CITY OF ALBUQUERQUE

Re: Precision Eye Center 7521 Alameda Blvd. NE Traffic Circulation Layout Engineer's Stamp 02-13-23 (C19-D070)

Based upon the information provided in your submittal received 03-16-23, the above referenced plan cannot be approved for Building Permit until the following comments are addressed:

Number: **C-101a**

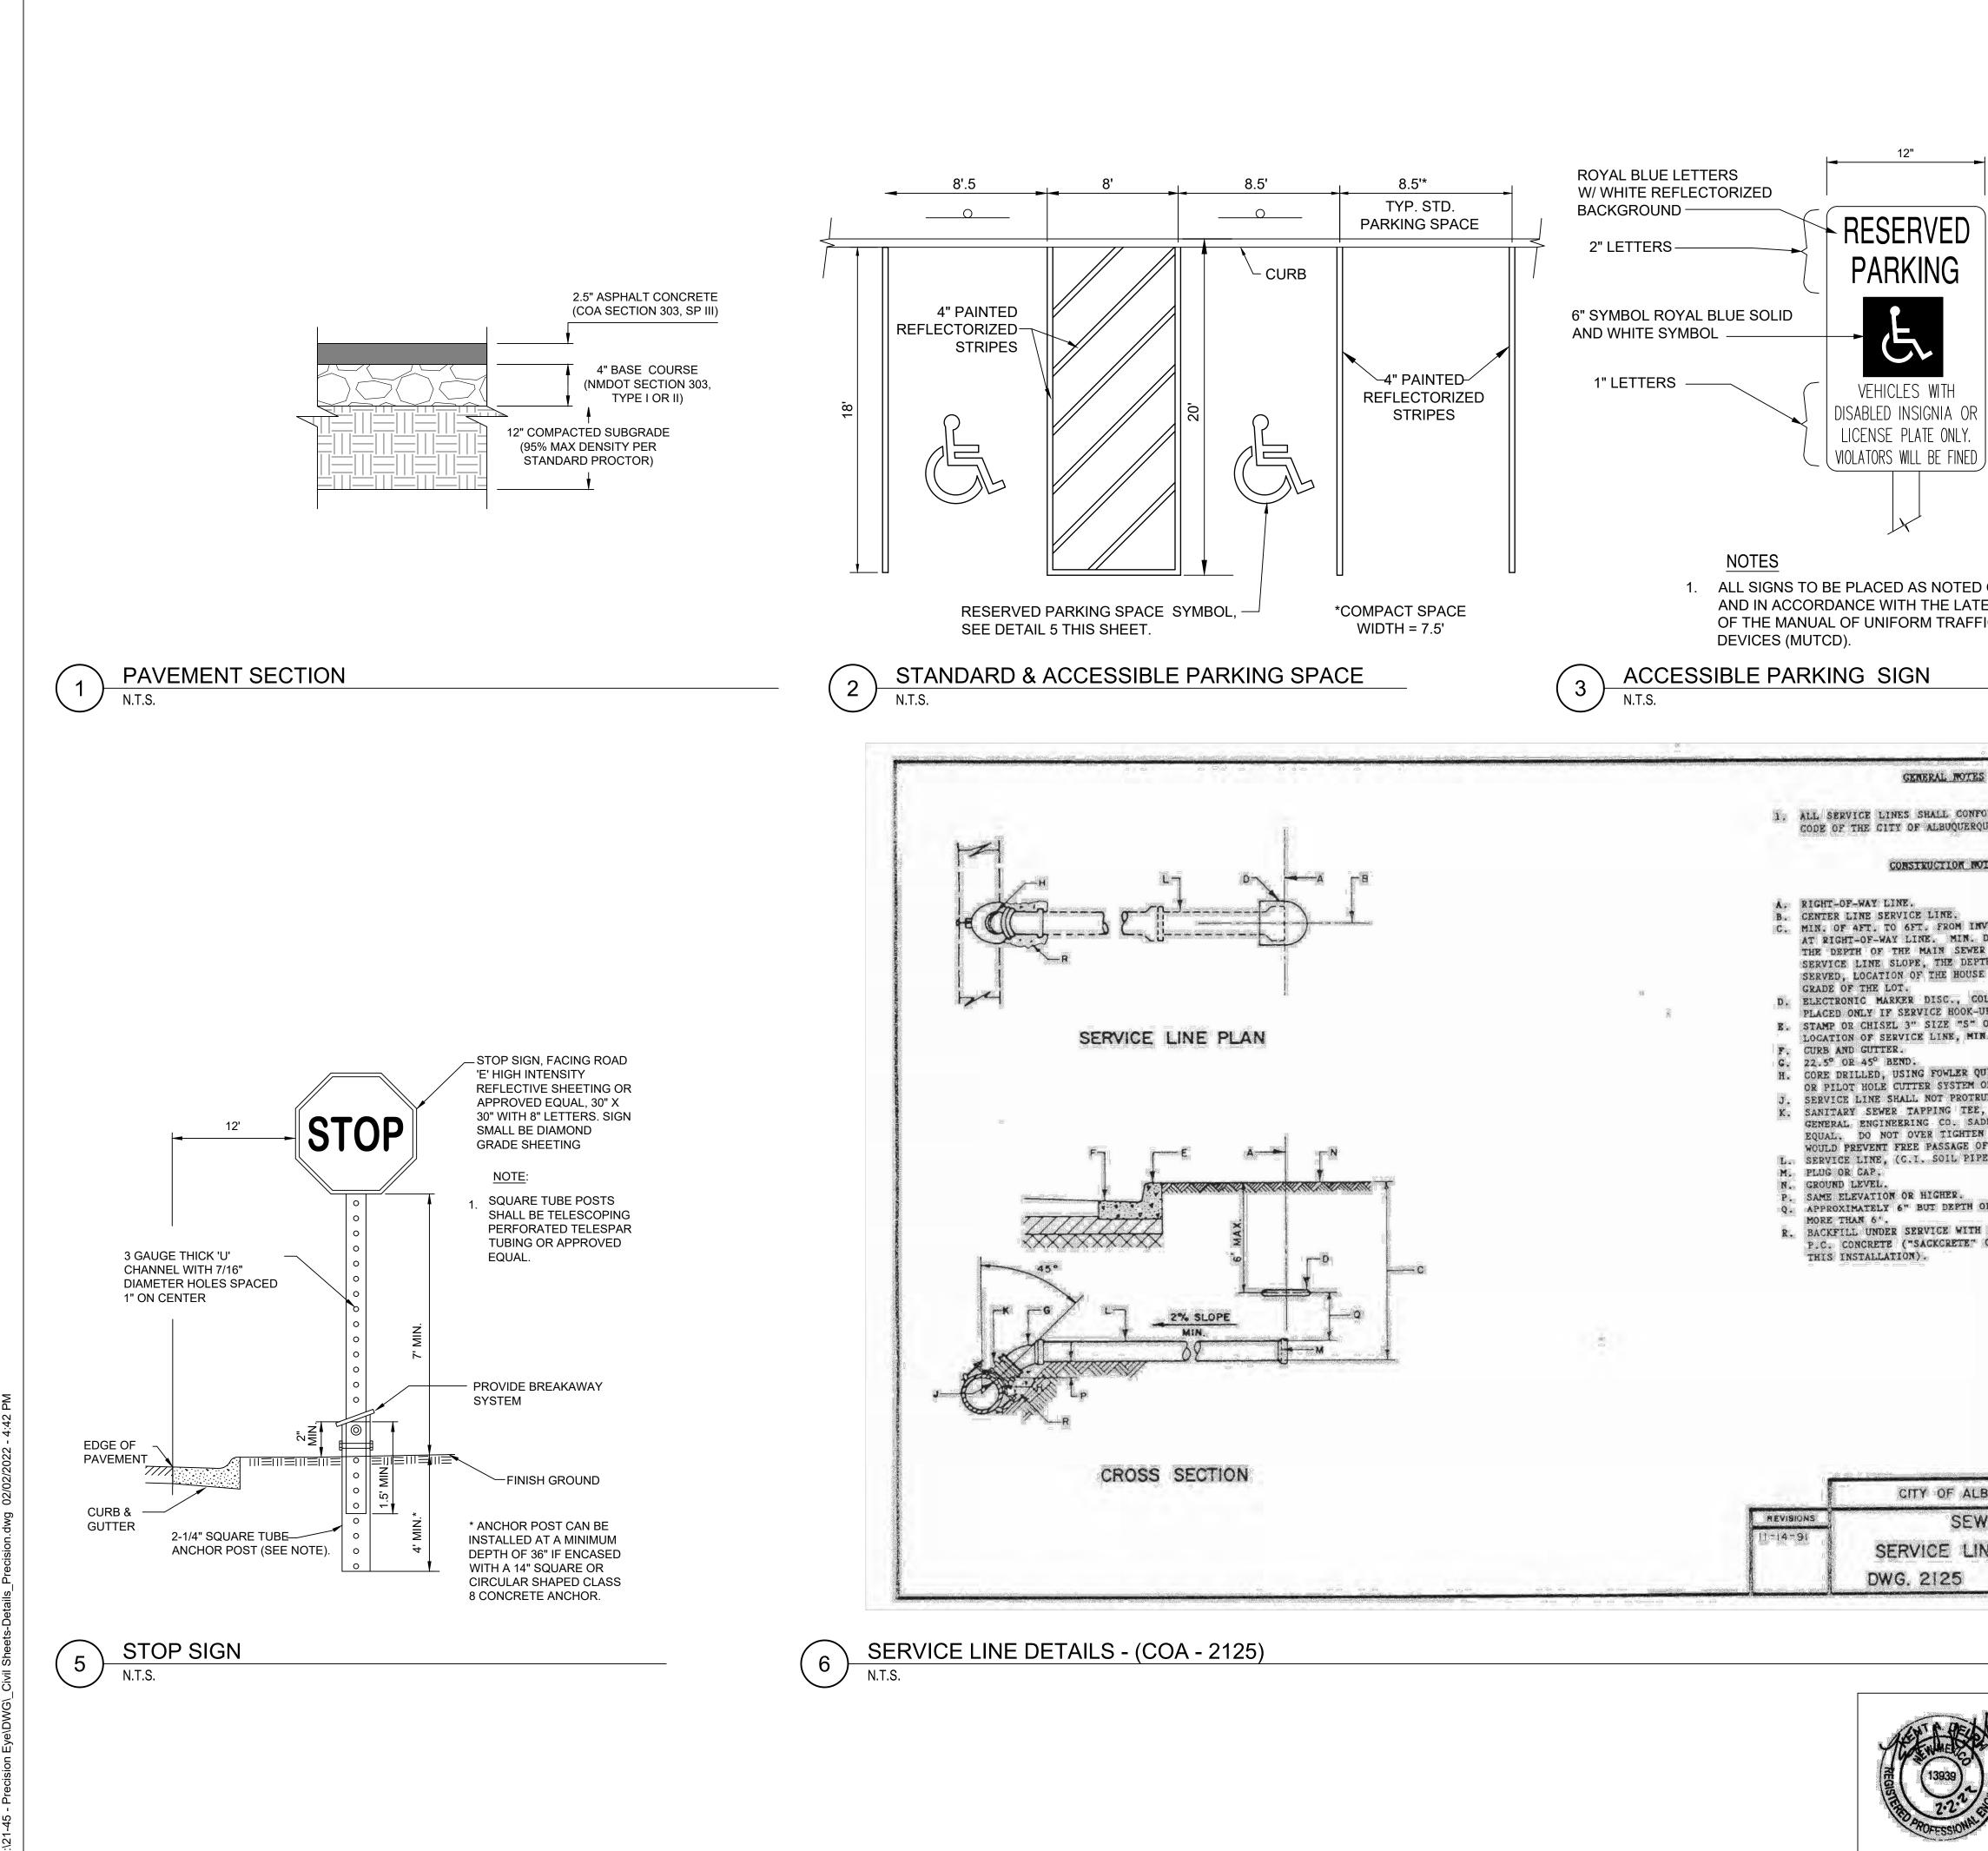
Per City standard Compact parking space should be minimum 15 ft. in length.

The ADA access aisles shall have the words "**NO PARKING**" in capital letters, each of which shall be at least one foot high and at least two inches wide, placed at the rear of the parking space so as to be close to where an adjacent vehicle's rear tire would be

- 4. A 5 ft. keyway is required for dead-end parking aisles.
- 5. Please remove Plumbing details from Transportation details' sheet D-101.
 - 6. Refuse vehicle maneuvering shall be contained on-site. The refuse vehicle shall not back into the public right of way.; provide a copy of refuse approval.
